Reference: Hanford Waste Vitrification Plant
DOE Contract DE-AC06-86RL10838
Fluor Contract 8457

DESIGN CHANGE NOTICE

DCN -0100 | REV 0 | PAGE 1 OF 18

DCN TITLE: THIS DCN-0100 SUPERSEDES "DCN-0096" & "DCN-0096 REV 1"

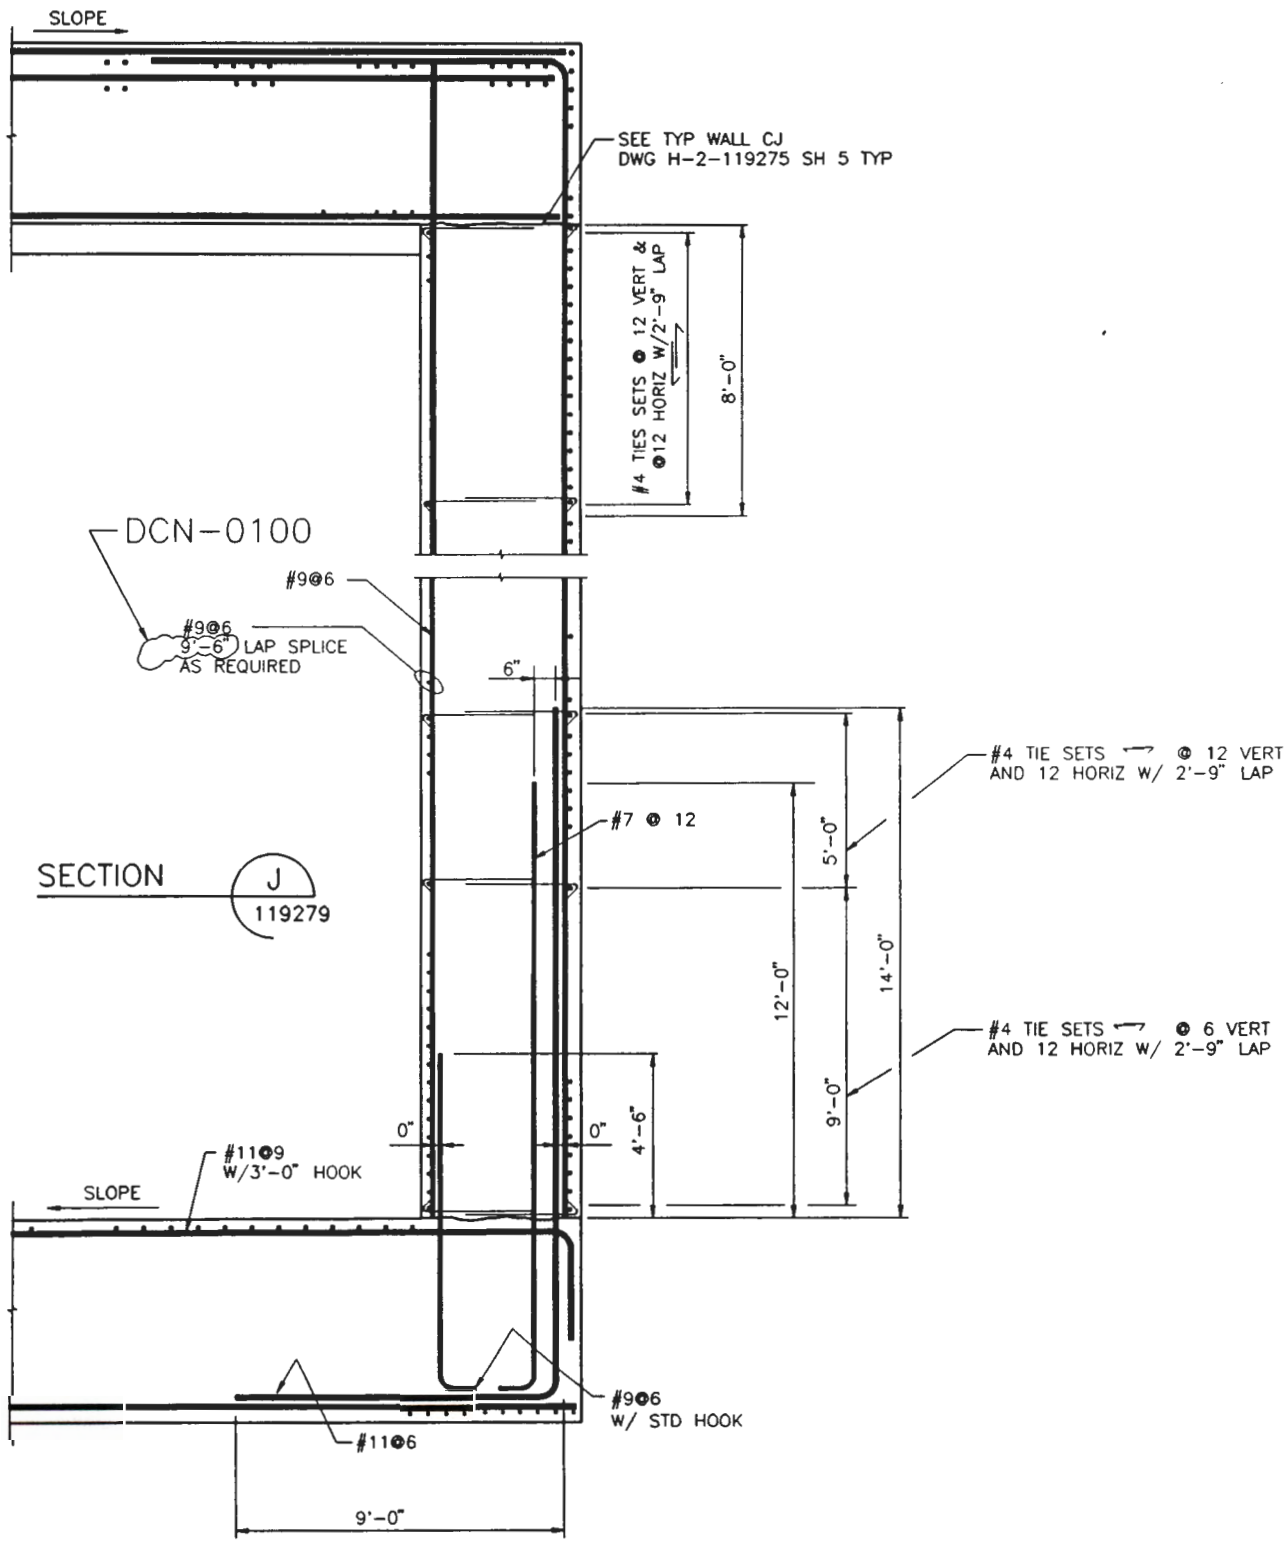
DESCRIPTION OF CHANGE: REVISE LAP SPLICE

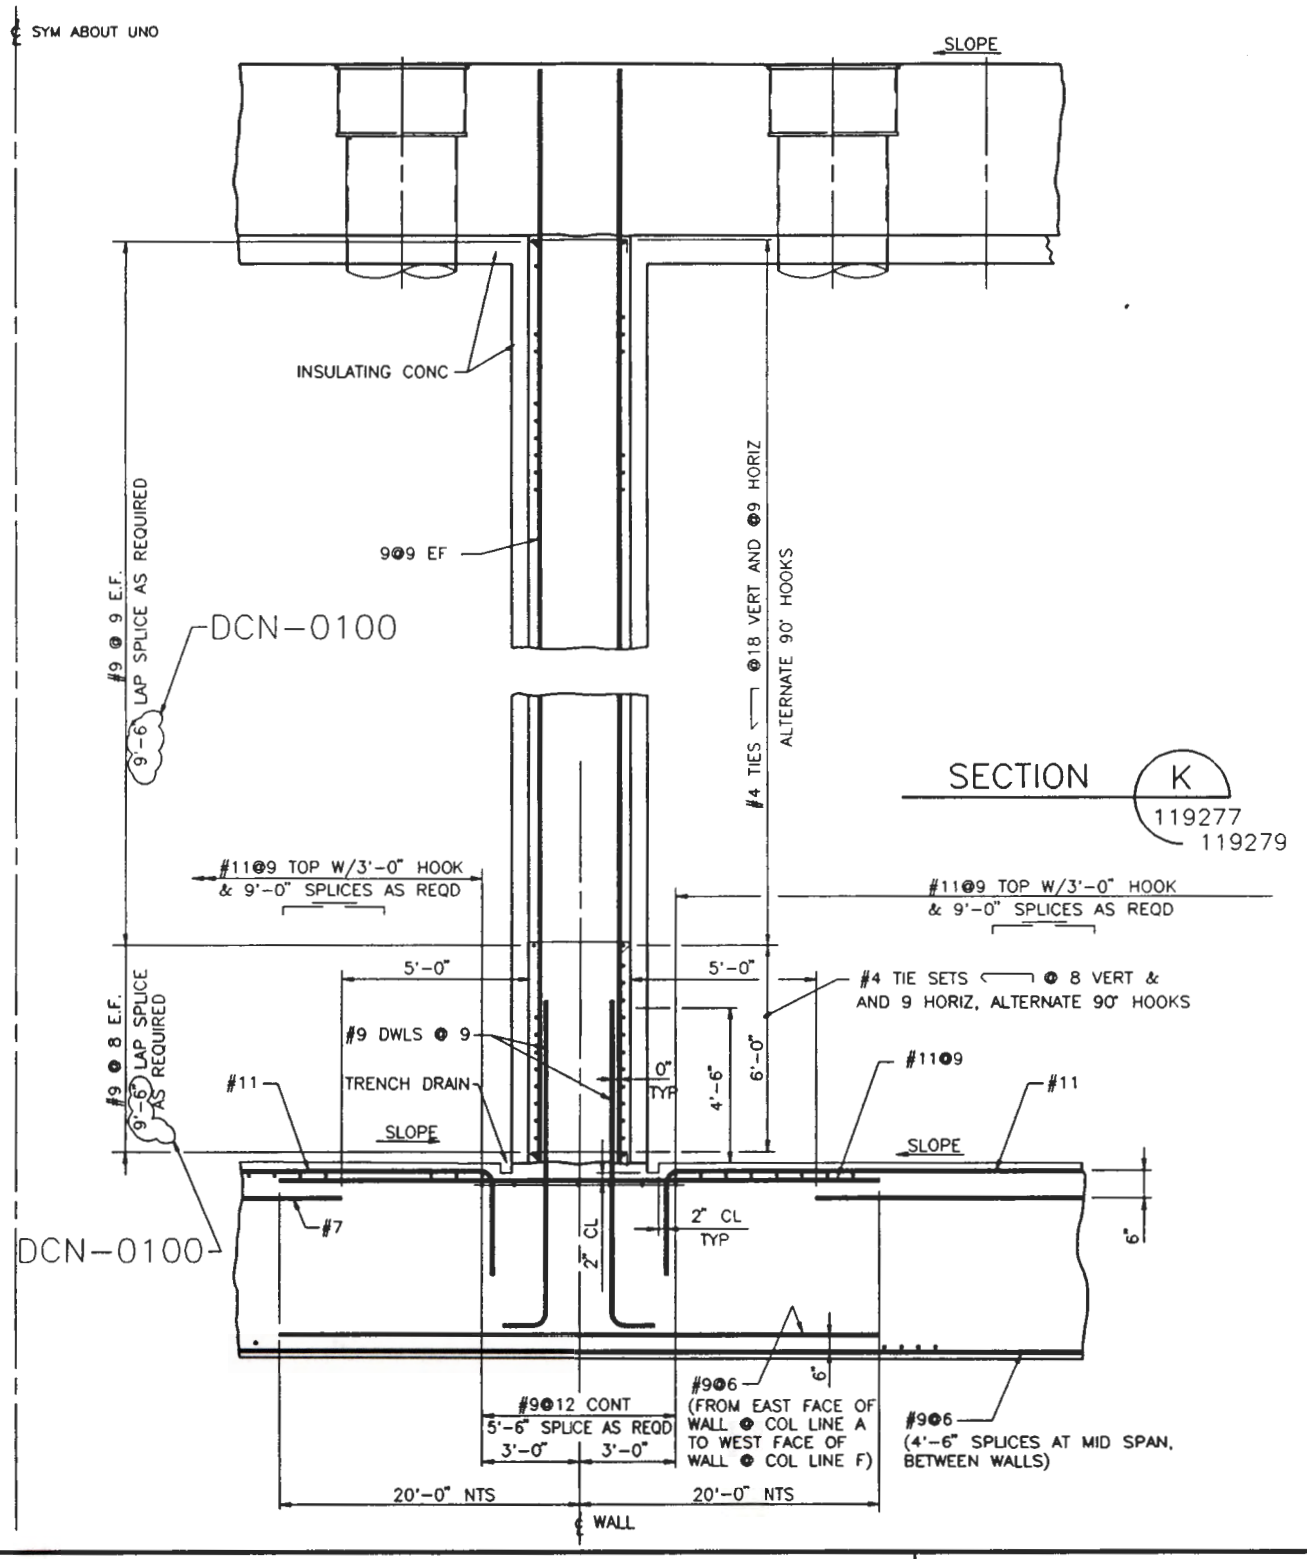
REVISE LAP SPLICE
